SUBJECT: Conservation District Use Permit (CDUP) OA-3297

This is to inform you that on May 26, 2006, the Board of Land and Natural Resources approved your client's Conservation District Use Application (CDUA) for the Duke Kahanamoku Lagoon Restoration Project located at Kalia, Waikiki, island of Oahu, portion of TMK: (1) 2-3-037:021 subject to the following conditions:

Plan for Fulfilling Conditions Relating to the Hawaiian
Village Lagoon
Hilton Hawaiian Village - Waikikian Project
Special Management Area Permit (SMA) No. 2002/SMA-19

Figure 2-14:

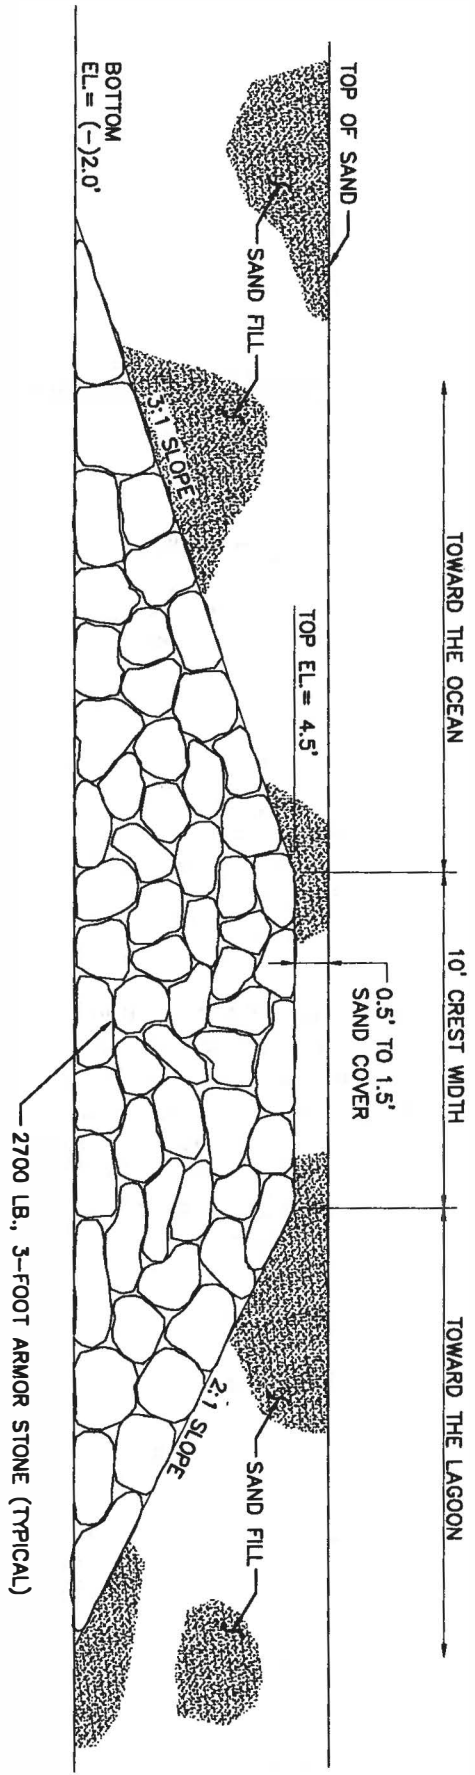
1. There are concerns regarding the proposed “buried rubble mound structure” seaward of the lagoon. We recommend increasing dune height through dune restoration or creation as an alternative to construction of a buried seawall. We understand that this is historically an engineered coastline and will require continued maintenance. An alternative to a natural dune would be a hard structure that is continually covered in sand as part of the Operation and Maintenance plan.

The proposed design for the shoreline berm is the hard structure suggested as an alternative. It consists of large (2,700 pound) armor stone located a minimum of 40' inland of the certified shoreline that will be continually buried under a sand cover. It is far inland from the active beach zone and does not constitute a buried seawall. HHC accepts that maintenance will be required to keep the sand cover in place, particularly on areas where the buried structure is closest to the surface, and agrees to assume responsibility for that maintenance. The following will be added to the operations and maintenance activities:
